UNITED STATES
DEPARTMENT OF THE INTERIOR
BUREAU OF LAND MANAGEMENT

FORM APPROVED
OMB NO. 1004-0135
Expires: July 31, 2010**SUNDRY NOTICES AND REPORTS ON WELLS**
*Do not use this form for proposals to drill or to re-enter an abandoned well. Use form 3160-3 (APD) for such proposals.*5. Lease Serial No.
NMLC029548A
6. If Indian, Allottee or Tribe Name

☒ Oil Well ☐ Gas Well ☐ Other8. Well Name and No.
Multiple--See Attached2. Name of Operator
APACHE CORPORATION

Apache Corporation proposes to use a 13-5/8" 3M psi WP BOP (EXHIBIT 3) consisting of an annular bag type preventer. The BOP will be nipped up on the 13-3/8" surface csg head & tested to 2000psi using a test plug. After intermediate csg is set & cemented a 13-5/8" or a 11" 3M BOP consisting of an annular bag type preventer, middle blind rams, and bottom pipe rams (see EXHIBIT 3A) will be installed & utilized continuously until TD is reached. The BOP will be tested at 2000 psi (maximum surface pressure is not expected to exceed 2M psi). BHP is calculated to be approximately 2819 psi. All BOPs & associated equipment will be tested as per BLM Drilling Operations Order #2. The BOPs will be operated and checked each 24 hr period &

Drilling Location
H2S Safety Equipment Diagram
Exhibit 3A

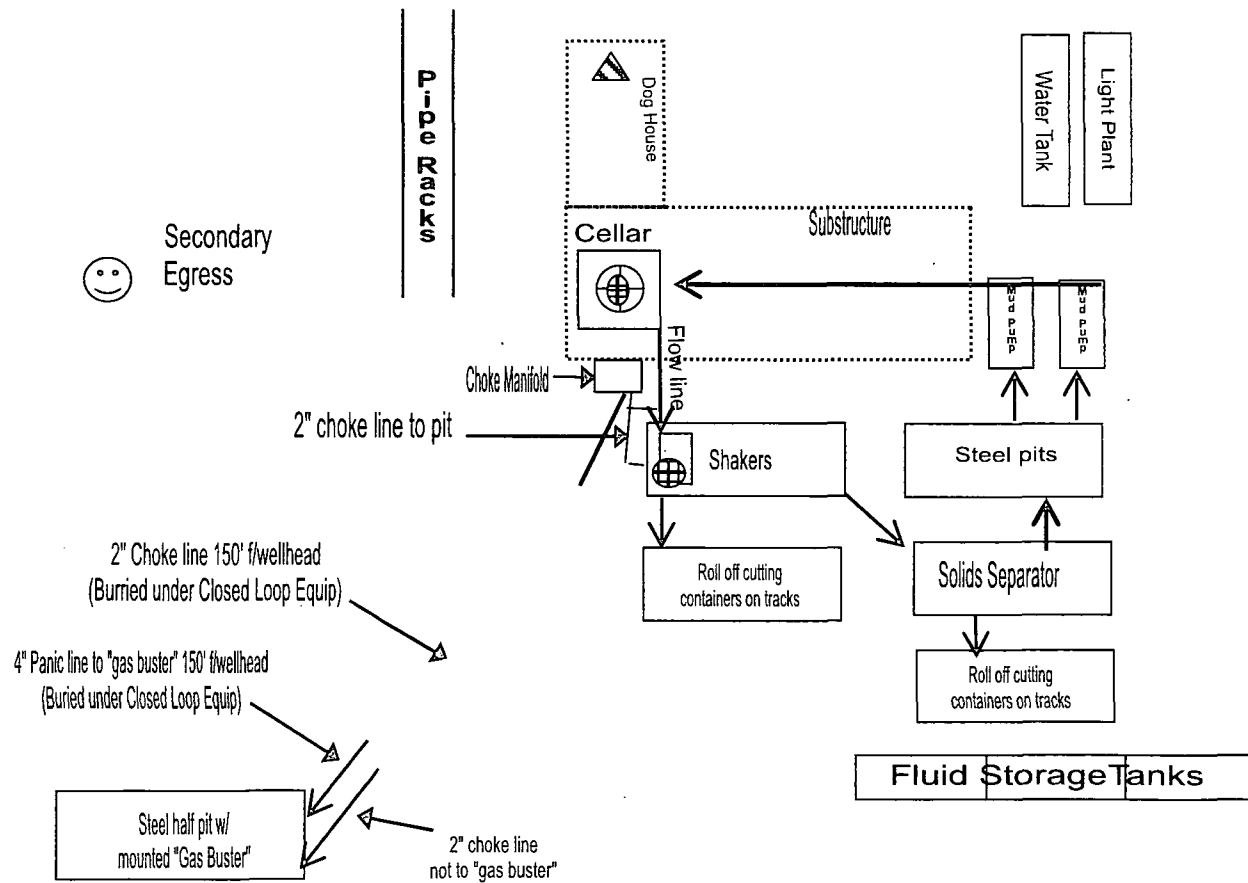
** Apache proposes and requests approval to use above BOP on the following APD's:
